SERVICE BULLETIN NO. MSB306-36/2

Reduction of V_{NE}

**G 102 Standard Astir III
G 102 Club Astir III / IIIb**

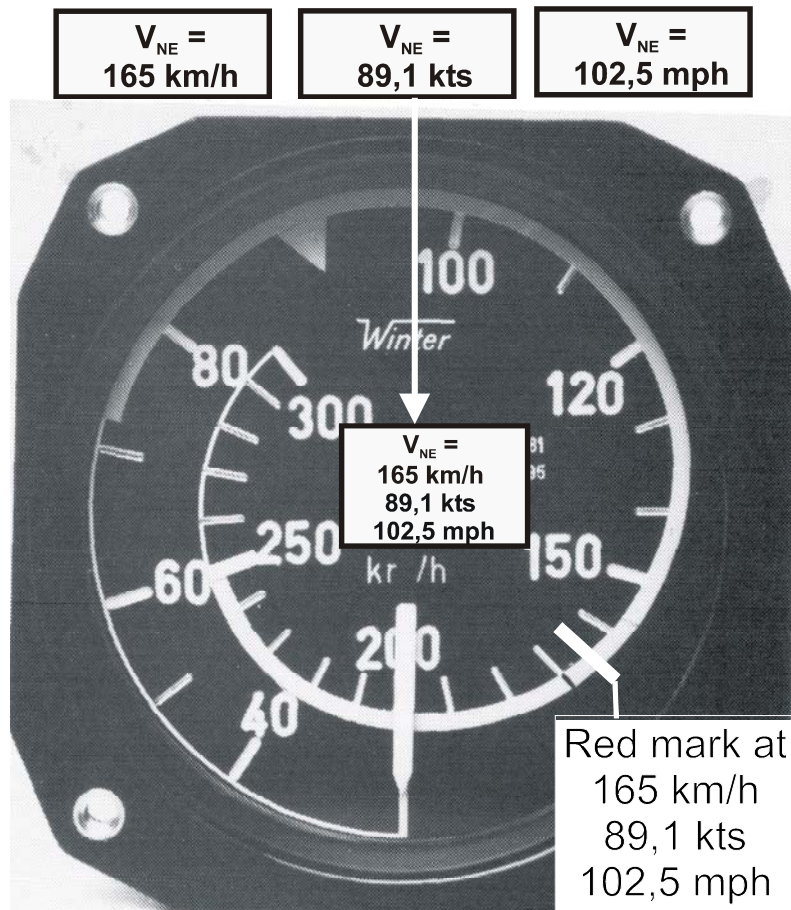
- 1.8.1 Apply a red mark on the airspeed indicator at **165 km/h (89,1 kts, / 102,5 mph)**
- 1.8.2 Apply the following red placard (according to airspeed indicator calibration) to the airspeed indicator:
